Access Compliance Report Public Rights-of-Way (Curb Ramps)

Main Street: N/A Cross Street: ESPERANZA_RD Location: NE

ADA ID: RPAT210923140541 Ramp Type: Type 7 - Directional 2 Initial Pass/Fail: Fail Overall Compliance: No Severity Score: 15

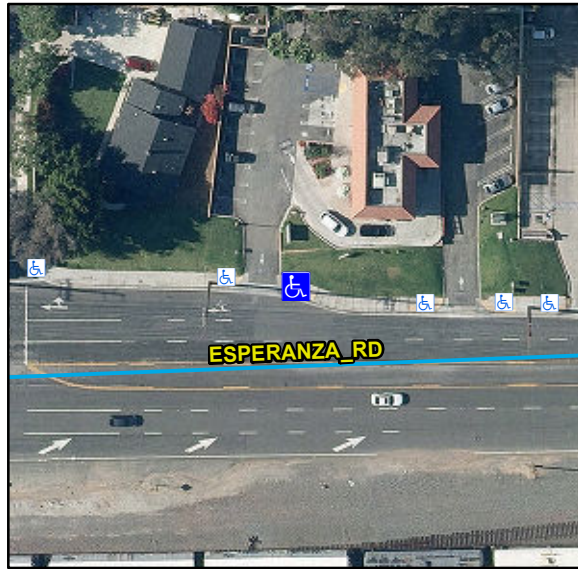
Remove & Replace Entire Ramp.

R304.2.2, STD 1115
